# UNITED STATES PATENT AND TRADEMARK OFFICE

APPLICATION NO.	FILING DATE	FIRST NAMED INVENTOR	ATTORNEY DOCKET NO.	CONFIRMATION NO.
10/657,343	09/08/2003	John Chen	P/144-321	1656
7590	03/08/2006			
OSTROLENK, FABER, GERB & SOFFEN, LLP 1180 Avenue of the Americas New York, NY 10036-8403			EXAMINER FIGUEROA, FELIX O	
			ART UNIT 2833	PAPER NUMBER

# Office Action Summary

## **DETAILED ACTION**

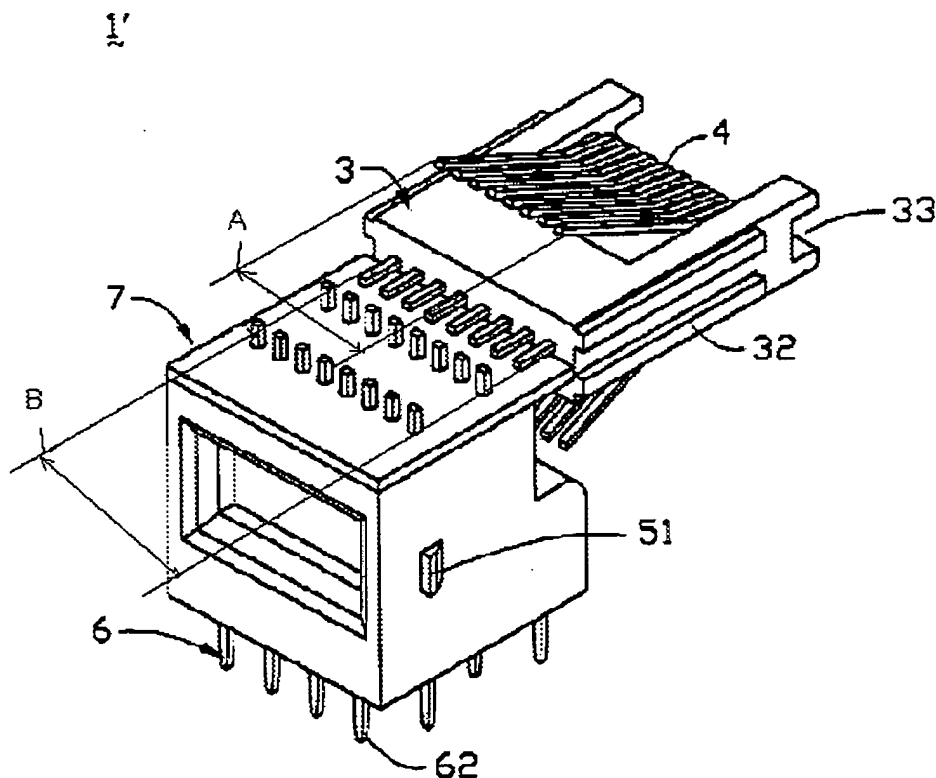
In response to Applicant's arguments regarding claim 6, please note that the overall space occupied by the first portion (A, as shown above) is smaller than that occupied by the second portions (B). Thus, the spacing between the second portions is greater than that of between the first portions.
